## NUCLEAR REGULATORY COMMISSION

### Exelon Generation Company, LLC; LaSalle County Station, Units 1 and 2

**ACTION:** Environmental assessment and finding of no significant impact; issuance.

Figure 1. Current and Proposed Temperature of Cooling Water Supplied to the Plant from the CSCS Pond Versus Time of Day Requirements

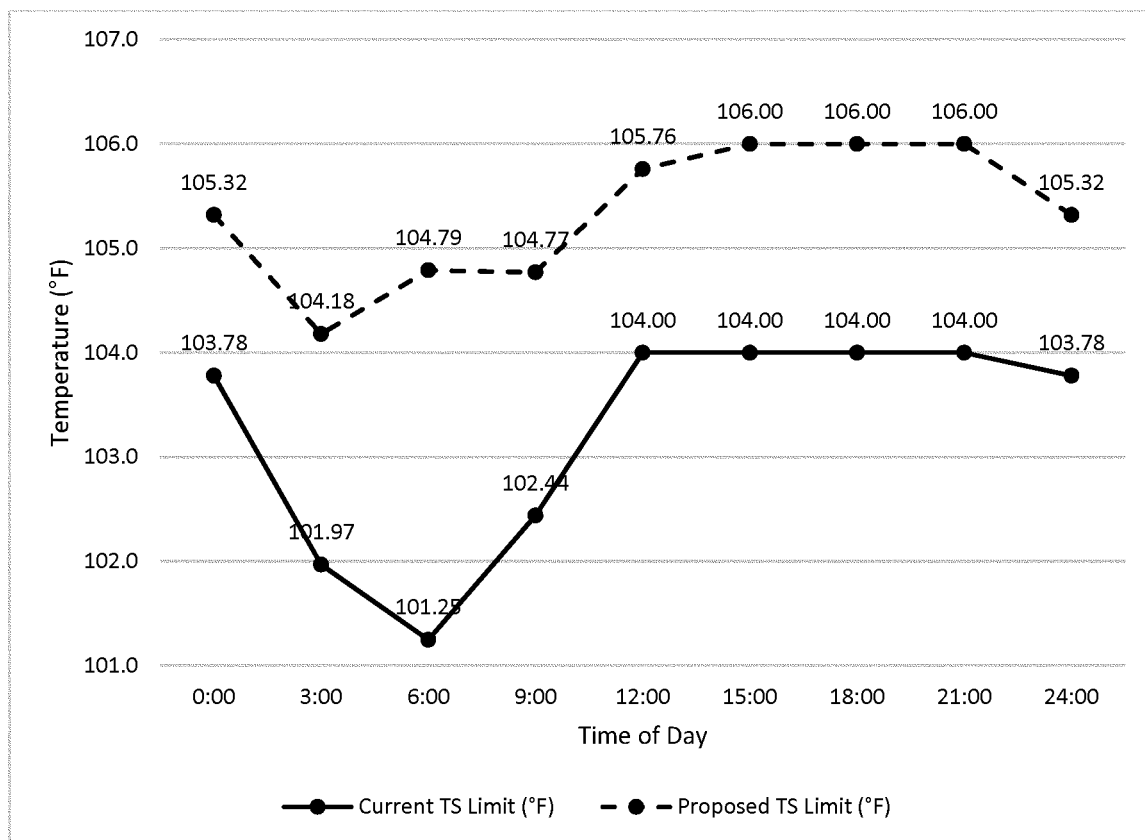
The proposed action would also modify the temperature curve associated with TS SR 3.7.3.1. This requirement currently states, "Verify cooling water temperature supplied to the plant from the CSCS pond is within the limits of Figure 3.7.3-1." Under the proposed action, Figure 3.7.3-1 would be modified to specify new diurnal temperature limits. The revised TS temperature limits would continue to vary with the diurnal cycle and would continue to limit the maximum temperature of the UHS supplied to plant safety systems to below 107 degrees Fahrenheit (°F) (41.7 degrees Celsius (°C)), the design limit of the plant. The revised limits would increase the allowable maximum UHS temperature of cooling water by 1.54 to 3.54 °F (0.85 to 1.97 °C) as compared to current limits and depending on time of day. Table 1 lists the current and proposed temperature limits, and Figure 1 depicts these limits graphically.

The NRC staff anticipates that thermal effects under the proposed action would be qualitatively similar to those described in the FSEIS. The primary difference under the proposed action would be an incremental increase in the likelihood in the summer that fish in the thermally affected portion of the cooling pond would experience thermal effects causally related to plant operation. This is because under the proposed action, Exelon could continue to operate LaSalle during periods of higher UHS temperatures when it would currently be required to shut down. However, because the UHS is a small portion of the cooling pond, the majority of the cooling pond would be unaffected by the proposed action, and fish would be able to seek refuge in those cooler areas. Therefore, only fish within the region of the cooling pond that is thermally affected by LaSalle's effluent discharge (e.g., the discharge canal, the flow path between the discharge canal and UHS, and the UHS itself) at the time of elevated temperatures would likely be affected. Thermal effects would be most intense in or near the discharge canal and would decrease across a thermal gradient extending from the discharge canal.
